Product Change Notice (PCN)

PCN Number: **PCN-0451091R-01**

Product(s) Affected: *PJ-043-SMT-TR*

| PREVIOUS CUI DEVICES DETAIL / IMAGE | | | NEW CUI DEVICES DETAIL / IMAGE | | |

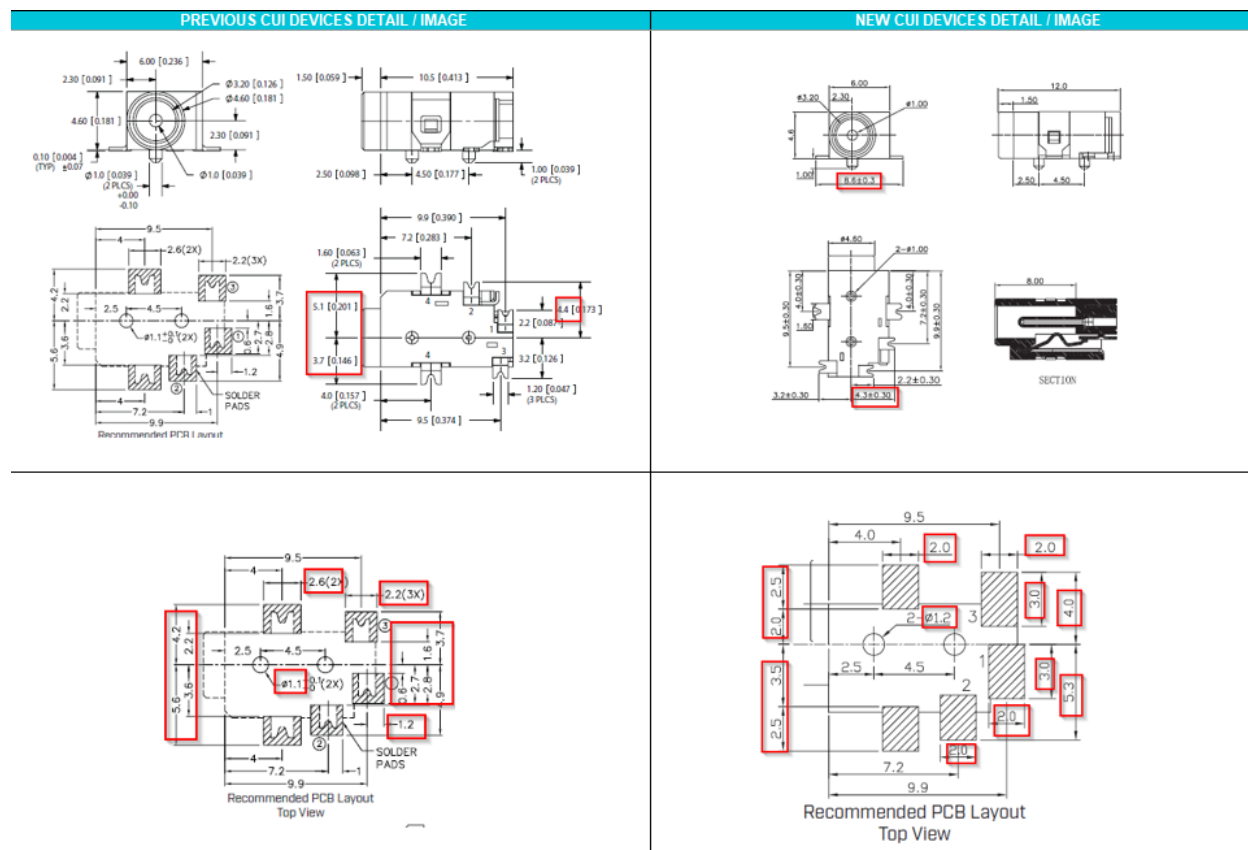
Description of Change: *Minor Housing and footprint differences. Material Change on the housing and terminals. See image Below*

| PREVIOUS CUI DEVICES DETAIL / IMAGE | | | NEW CUI DEVICES DETAIL / IMAGE | | |
|-------------------------------------|--------------------|---------|--------------------------------|----------------|---------------|
| | MATERIAL | PLATING | DESCRIPTION | MATERIAL | PLATING/COLOR |
| center pin | brass | silver | center pin | brass | tin |
| terminal 1 | brass | silver | terminal 1 | brass t-0.25 | tin |
| terminal 2 | copper alloy | silver | terminal 2 | SUS301 t-0.25 | tin |
| terminal 3 | brass | silver | terminal 3 | brass t-0.25 | tin |
| shield | cold rolled steel | nickel | shield | brass t-0.25 | tin |
| plastic | PA6T or equivalent | | housing | PA9T (UL94V-0) | black |
